Rezoning Application: PD 22-1706

Zoning Hearing Master Date: April 17, 2023

Introduction Summary:

Case Reviewer: Tim Lampkin, AICP

8.0 PROPOSED SITE PLAN (FULL)

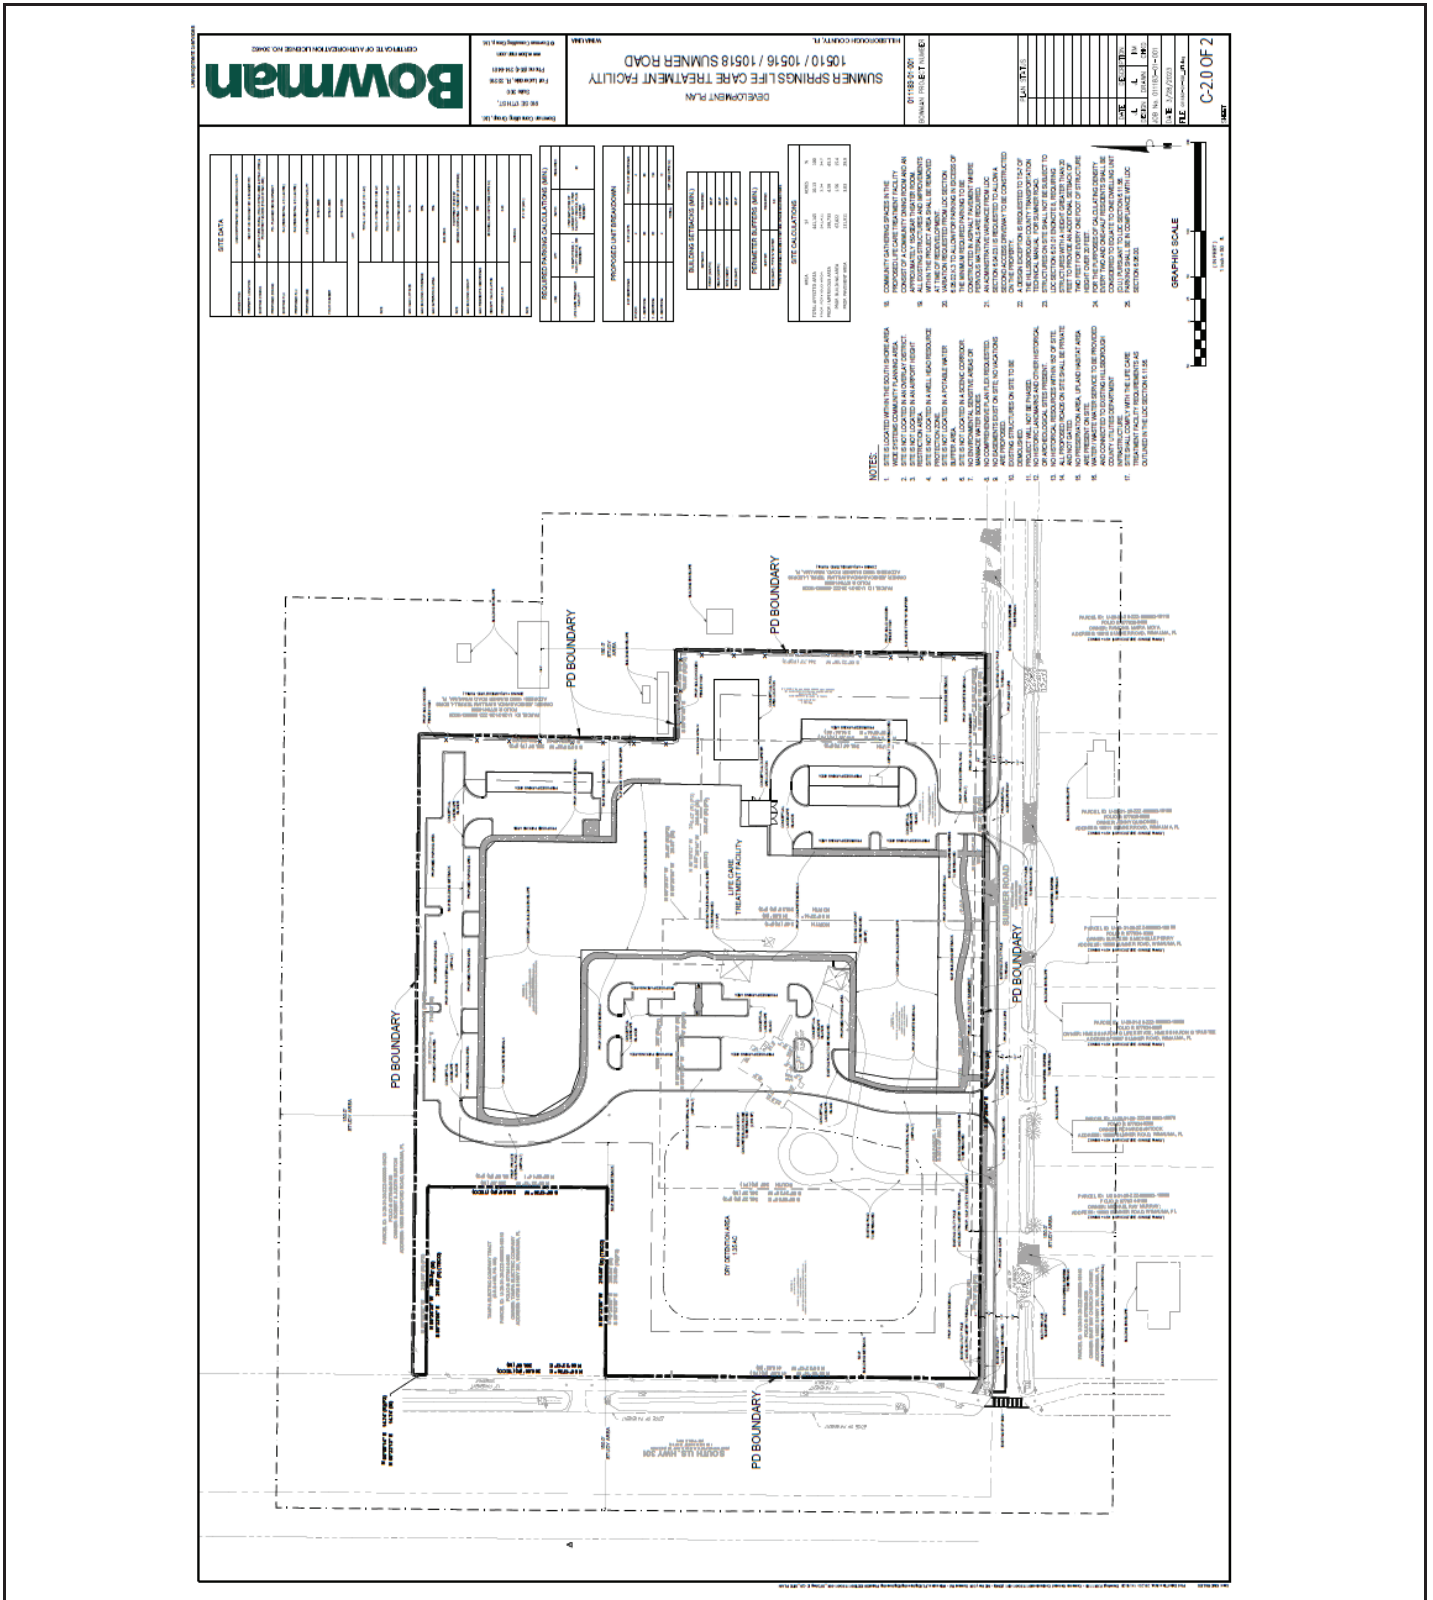
Prior to site plan certification, the applicant shall revise the PD site plan:

1. Include “5 ft. / Type A” buffer along the entire east and north perimeter buffer;
2. Correct all references on site plan acreage to “10.13 acres”;
3. Include “20 ft. Vegetated Area Buffer” adjacent to folio 77941.0450 on site plan;

4. Correct site data table “Perimeter Buffer” to add additional rows:
 - a. “North (rear)” under Side (East) – Type “A” Buffer
 - b. On site plan label “20 ft. Vegetated Area Buffer” adjacent to folio 77941.0450;

- c. Under site plan notes add: “Pursuant to conditions of approval, existing vegetation may be utilized in lieu of required screening pursuant to Land Development Code Section 6.06.06.C.12 adjacent to folio no. 77941.0450.”;

5. Unless the applicant desires to construct internal facilities as roadways complying with TS-3 standards, which would require a redesign of the entire project, the applicant shall revise Note 15 to indicate that proposed facilities onsite are driveways (not roadways);

6. Correct typo within Note 18 i.e. “Seat”;
7. Revise note 22 to address the appropriate Typical Section standard reference(s), as necessary. Staff notes the applicant is constructing certain elements of a TS-3 roadway; however, other portions of the roadway are remaining rural (consistent with a TS-7 roadway); and,

8. Replace note 25 with a note stating, “Parking shall be provided in accordance with Section 6.05 of the Hillsborough County LDC, except as otherwise noted within the conditions of zoning approval.”
